BID NUMBER: S6CA0240

TITLE: Purchase and Installation of Deicing (Tank) System for Northeast Airport (PNE)

ADDENDUM # 1

ADDENDUM # 2

GRADING PLAN WITH ALTERNATE 2 SHOWN

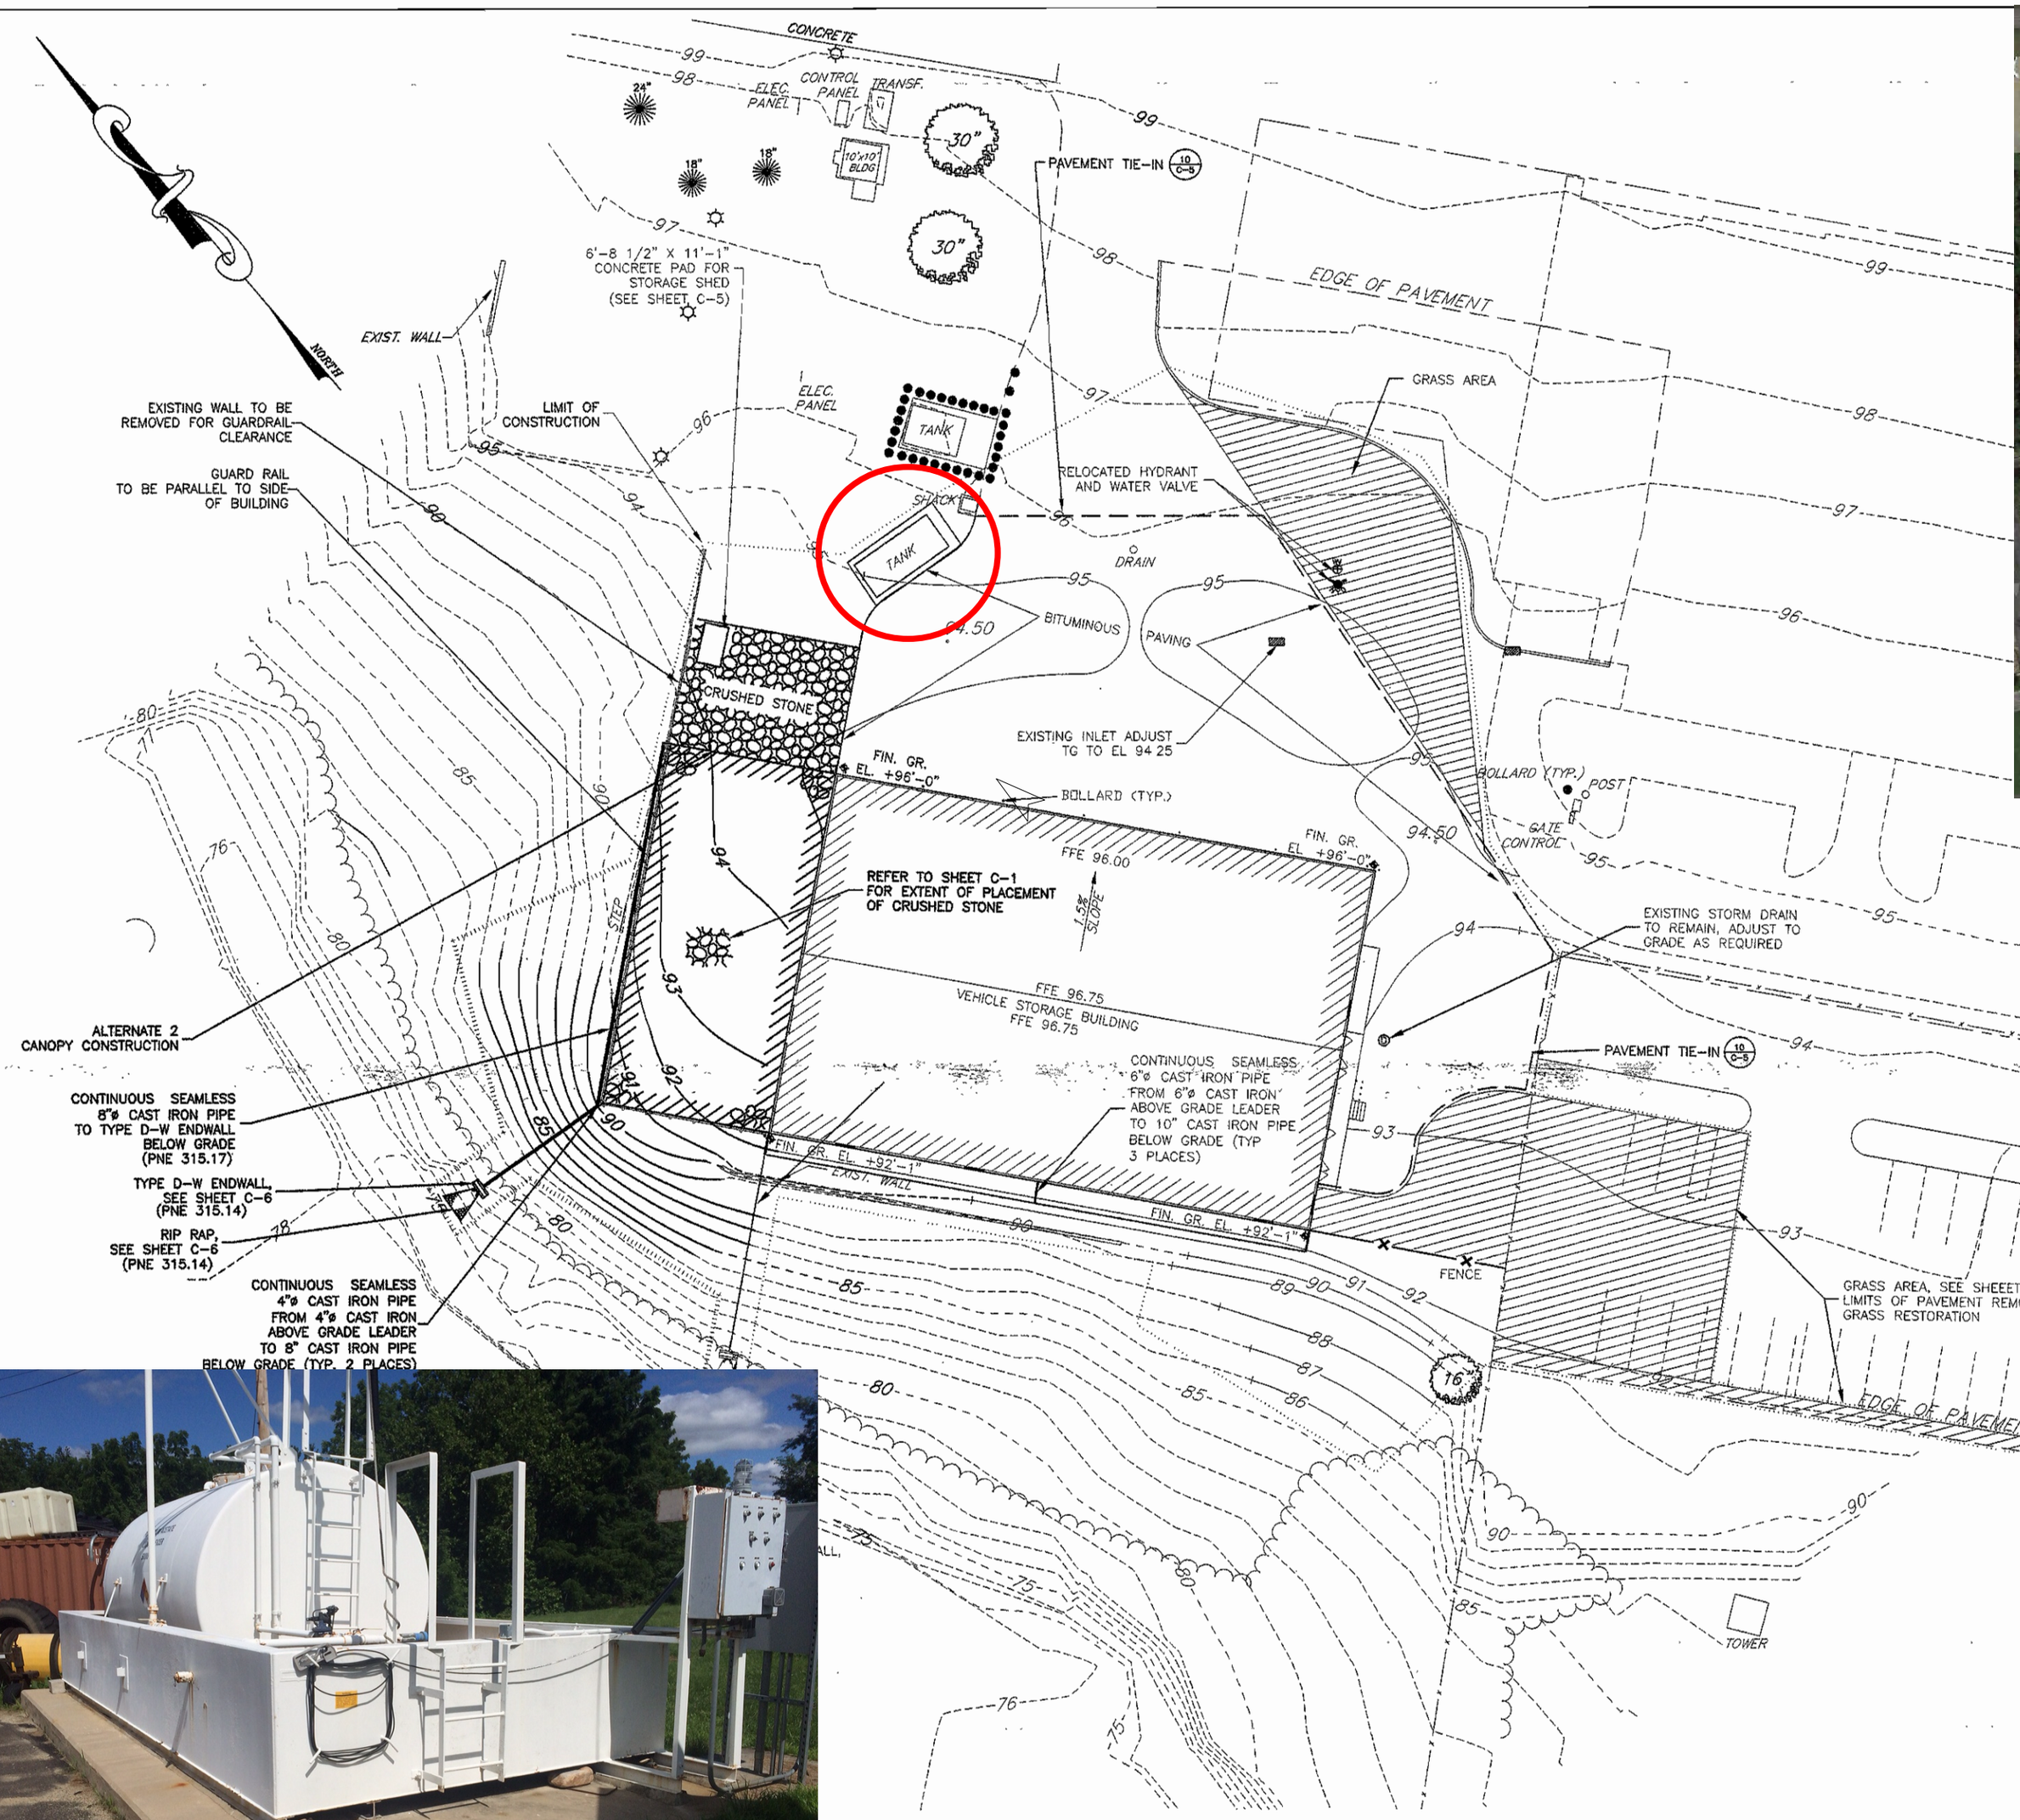
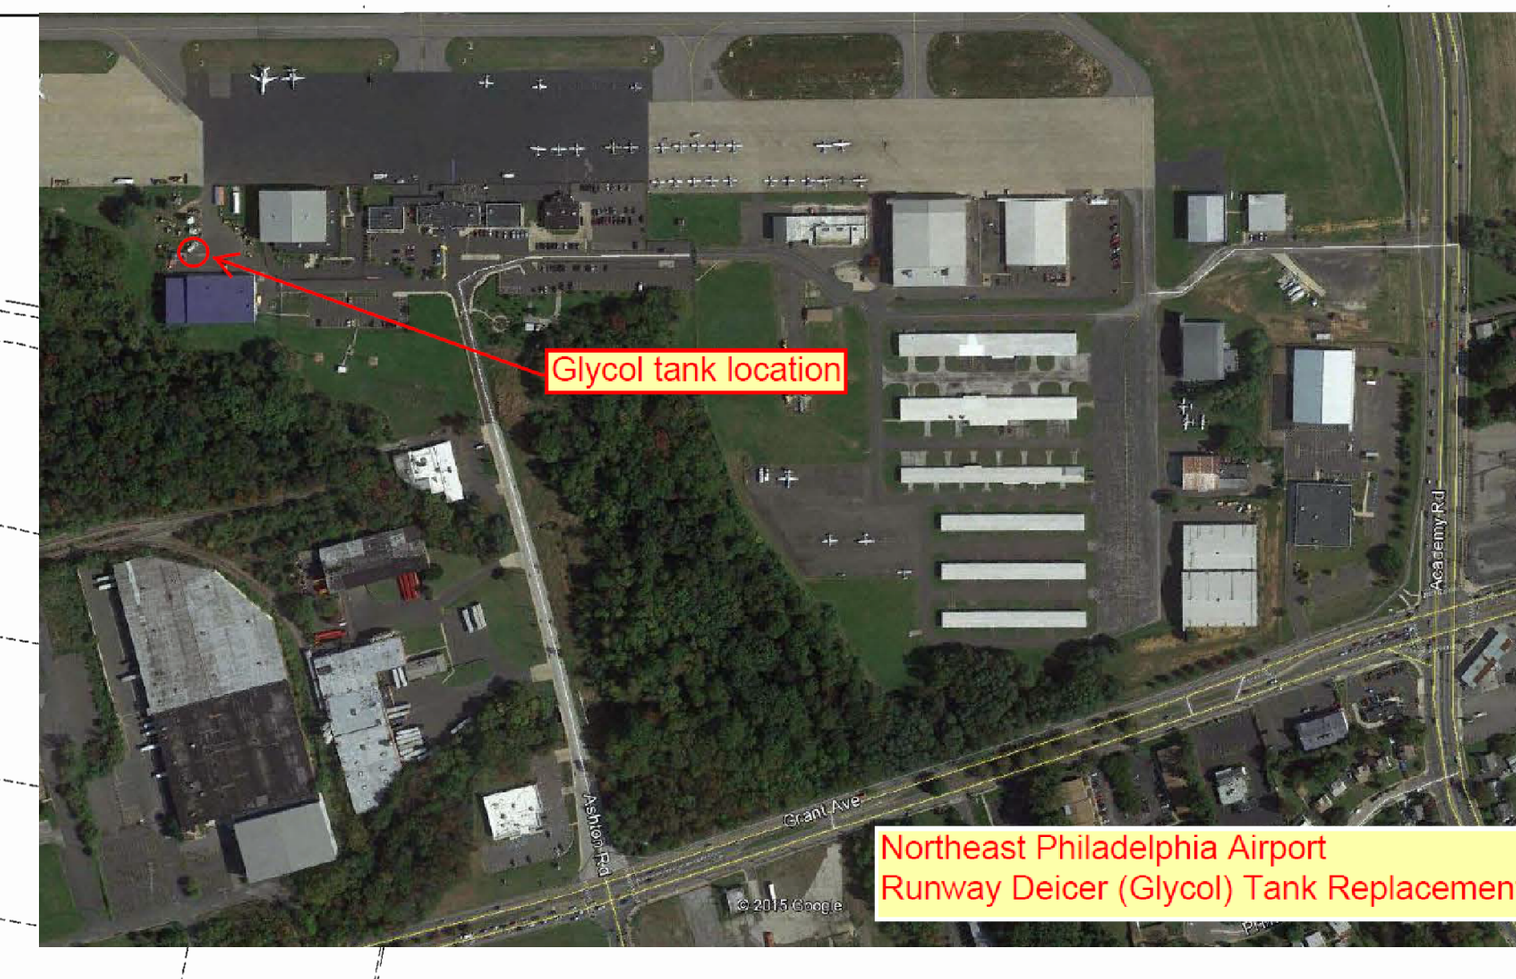
2. Can PHL provide existing Grading plans for use in L&I permitting?
   I don't have grading plans that would have to come through engineering

Exhibit "A"

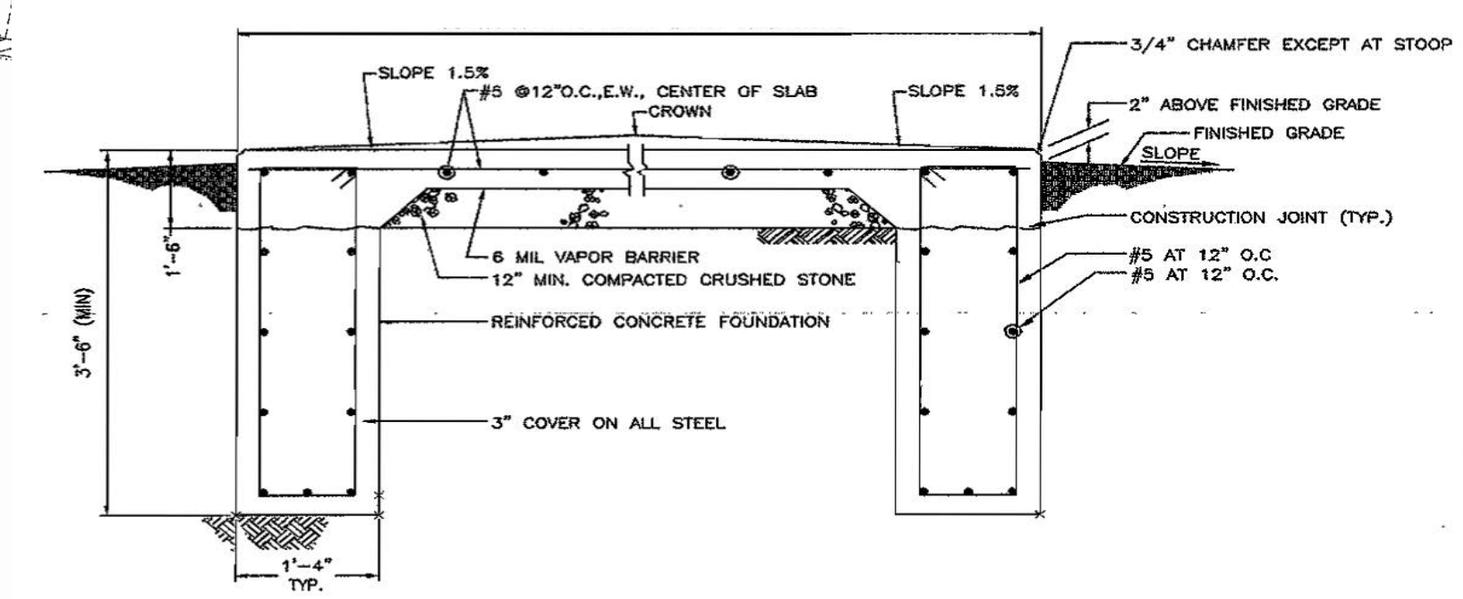
1. Please provide a larger view of the foundation detail shown on the bottom corner of Exhibit "A".
   We can send the Exhibit in a .pdf file over email which can then be zoomed in on
